# ADDENDUM TO THE STORM WATER DATA REPORT

# FOR THE INTERSTATE 80/GILMAN STREET INTERCHANGE IMPROVEMENT PROJECT

ALAMEDA COUNTY, CALIFORNIA
District 04 -ALA – 80 – POST MILE 6.38 / 6.95
EA 04-0A7700 / Project ID# 0400020155

NOVEMBER 2018

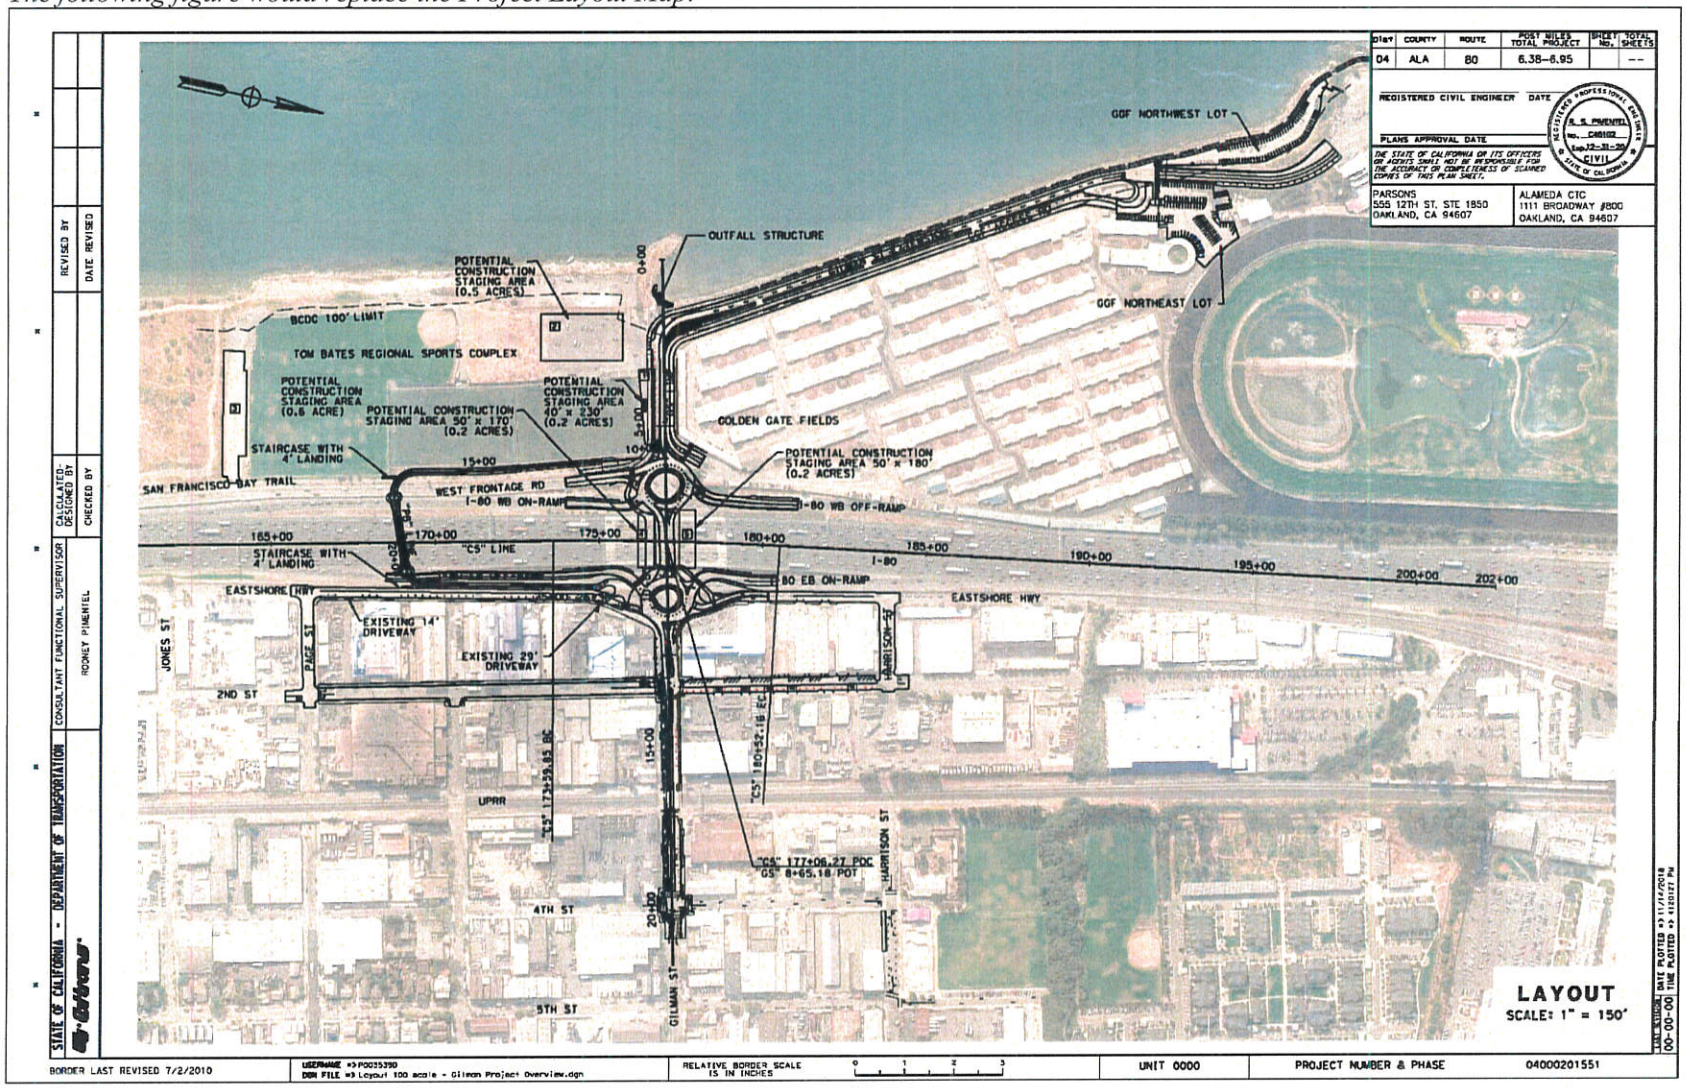
*The following figure would replace the Project Layout Map:*

**Outfalls and Downstream Flow Patterns**

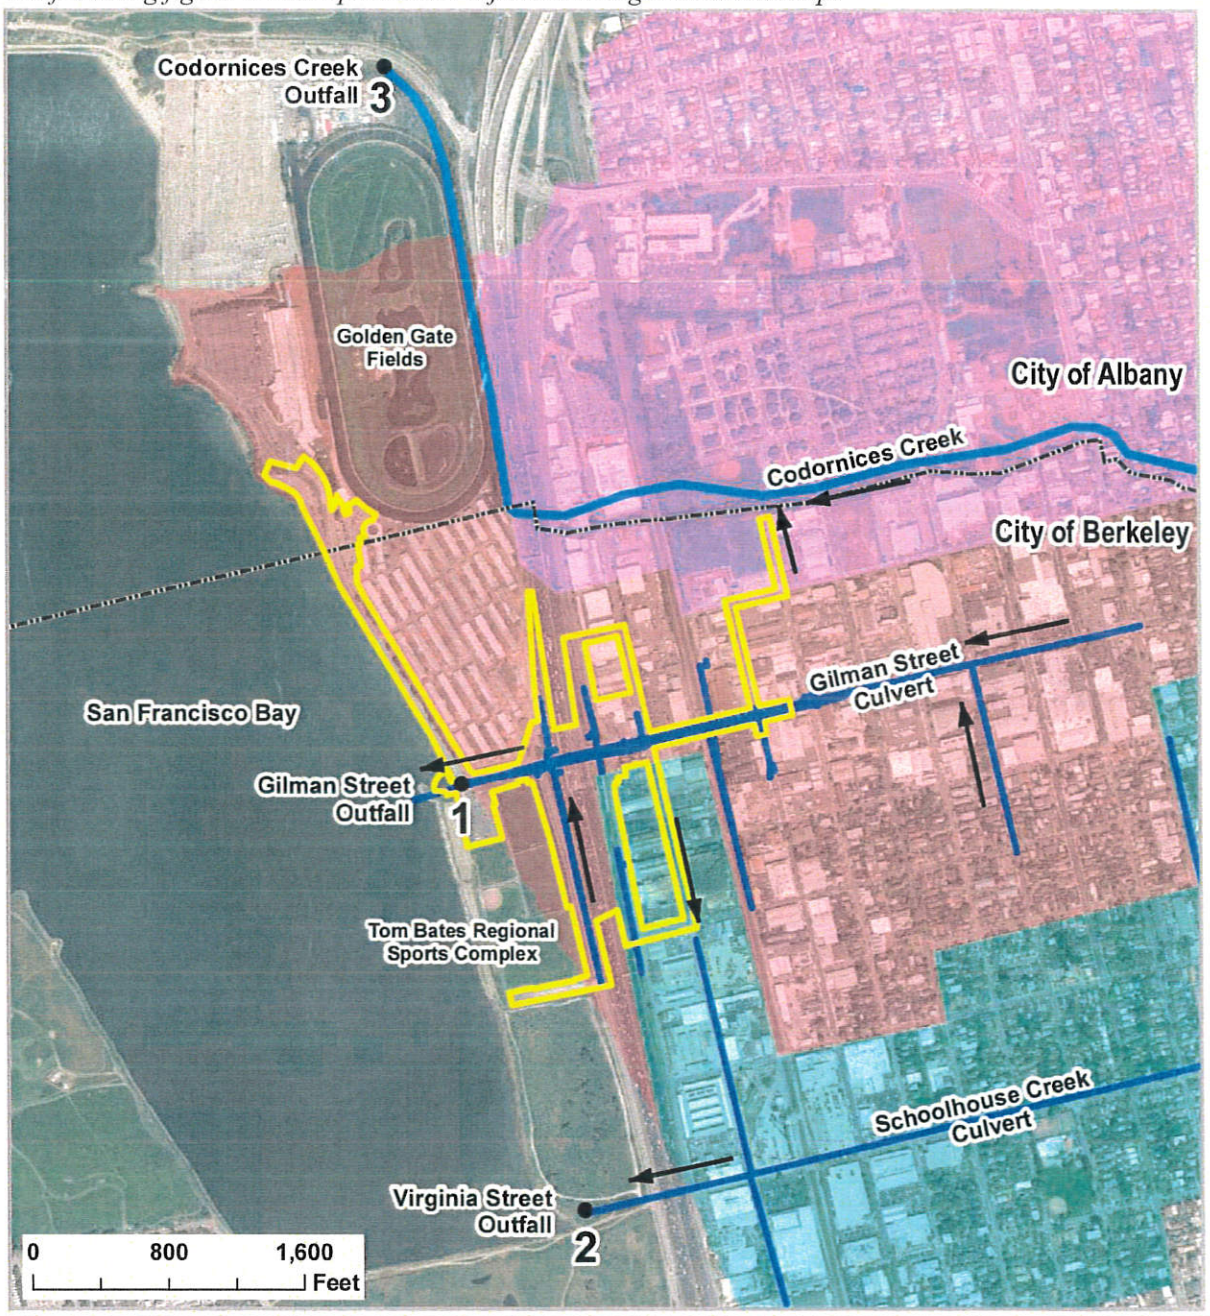
*The following figure would replace the Project Discharge Locations Map:*

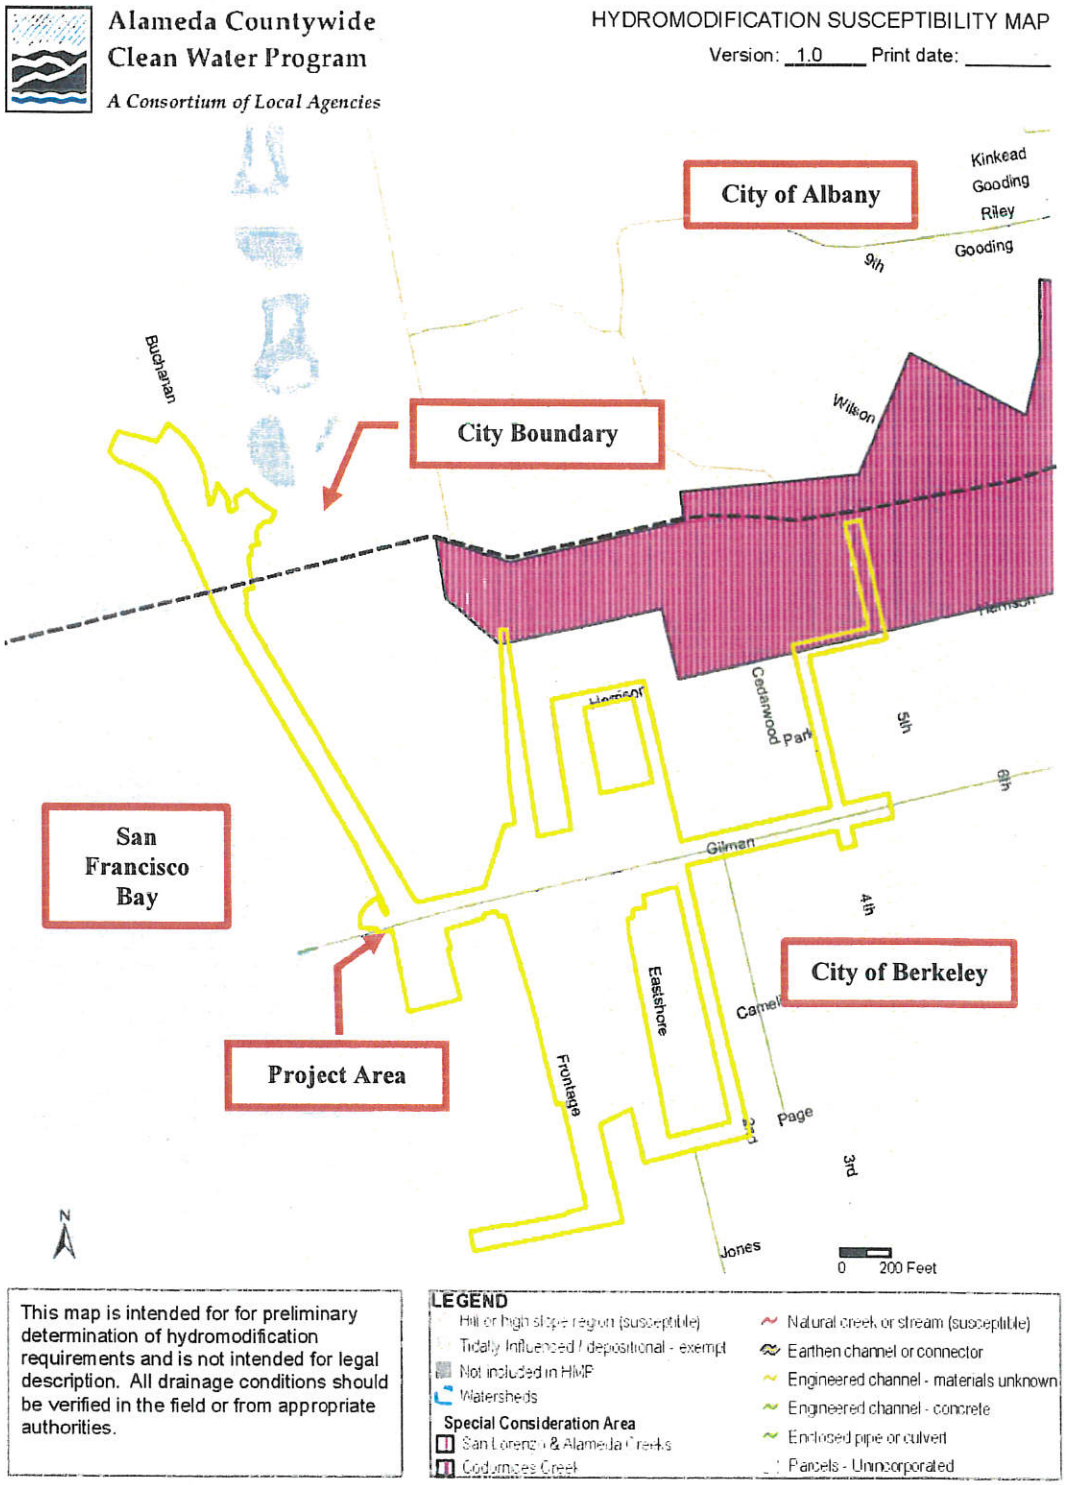
*The following figure would replace the Hydromodification Susceptibility Map:*
